DART AEROSPACE LTD	Work Order:	129308
Description: Crosstube Assembly	Part Number:	D206-667-243
Inspection Dwg: D206-667-243 Rev: C		Page 1 of 2

DART AEROSPACE LTD HAWKESBURY, ONTARIO, CANADA	
DRAWING NO. D206-667-243	REV. C SHEET 1 OF 4
TITLE CROSSTUBE ASS'Y (206L HIGH AFT)	SCALE NTS
COPYRIGHT © 2000 BY DART AEROSPACE LTD THIS DOCUMENT IS PRIVATE AND CONFIDENTIAL AND IS SUPPLIED ON THE EXPRESS CONDITION THAT IT IS NOT TO BE USED FOR ANY PURPOSE OR COPIED OR REPRODUCED IN ANY MANNER WITHOUT WRITTEN PERMISSION FROM DART AEROSPACE LTD.

DRAWING NO. D206-667-243	TITLE CROSSTUBE ASS'Y (206L HIGH AFT)	REV. C	DART AEROSPACE LTD ENGINEERING ORDER		D.E.O. NO. D206-667-243-C-1	SHEET NO. SHEET 1 OF 1	SCALE NTS
DRAWN <i>JP</i>	CHECKED <i>ADS</i>	MFG. APPR. <i>RB</i>	APPROVED <i>MD</i>		DE APPR. <i>#</i>		
DATE 11.07.15	DATE 11.07.20	DATE 11.07.21	DATE 11/07/21		DATE 11.07.21

REPLACE MAGNOBOND WITH PROSEAL.

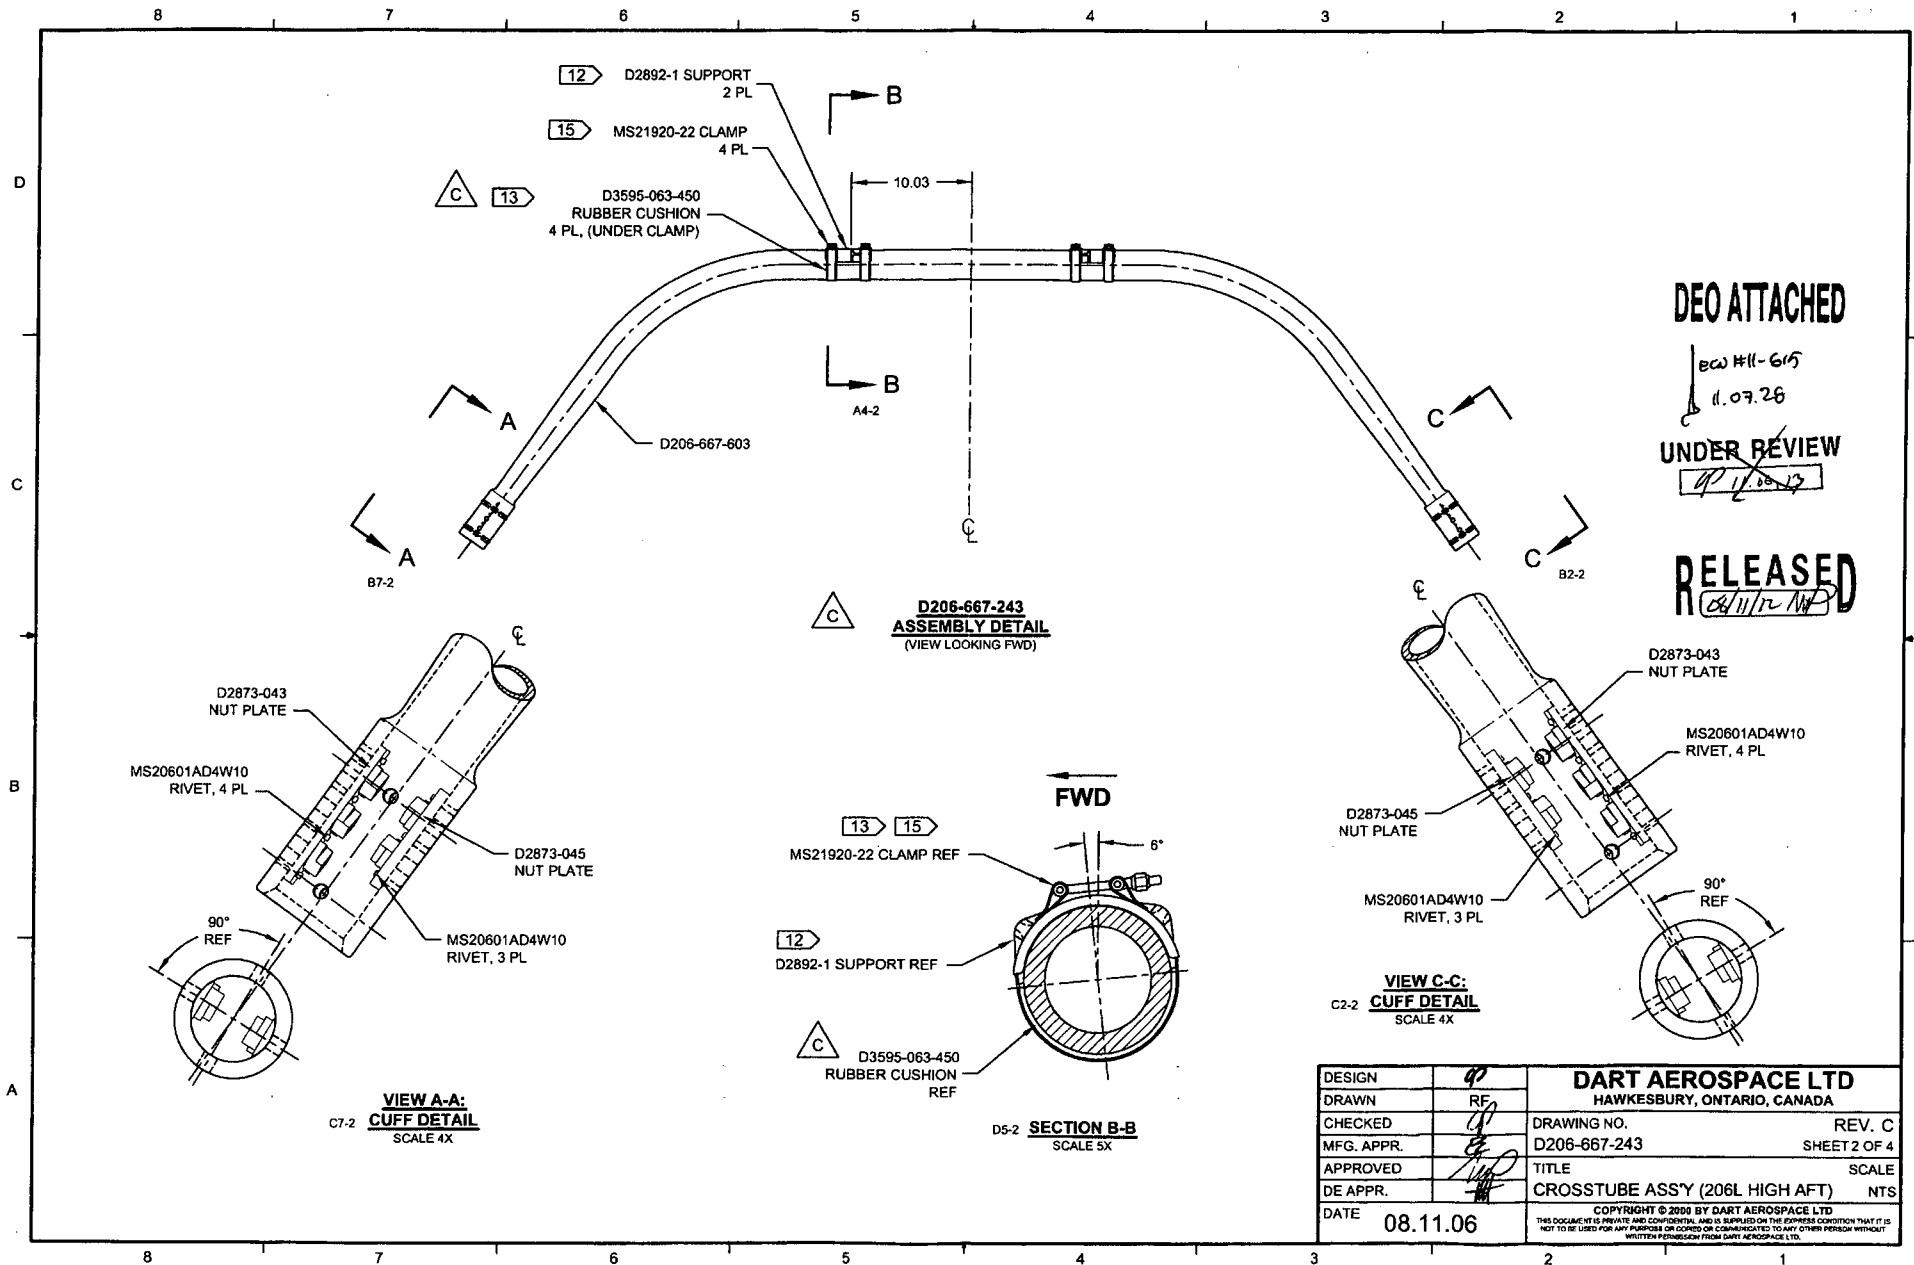
PURPOSE:

NOTE 12 & 15, SHEET 1 IS AMENDED AS FOLLOWS:

Item	Qty -243	Part Number	Description
9	A/R	PROSEAL 890 B-2	SEALANT, AMS-S-8802 CLASS B-2

- 12) TO INSTALL D2892-1 SUPPORT: ABRABE MATING SURFACE OF SUPPORT AND CROSSTUBE WITH 180-GRIT SANDPAPER AND REMOVE RESIDUE WITH MEK (OR EQUIVALENT). APPLY A 0.04" TO 0.07" THICK LAYER OF PROSEAL 890 CLASS B-2 (OR AMS-S-8802 CLASS B-2) SEALANT TO MATING SURFACE OF SUPPORT.
- 15) TORQUE CLAMPS 80 TO 100 IN-LB. ENSURE AT LEAST 1.5 THREADS SHOWING IN SAFETY AND THAT NUT HAS NOT BOTTOMED-OUT AFTER TORQUING. **PRIOR TO PACKAGING, RE-CHECK TORQUE ON CLAMPS AFTER PROSEAL 890 SEALANT HAS CURED FOR 72 HOURS.**
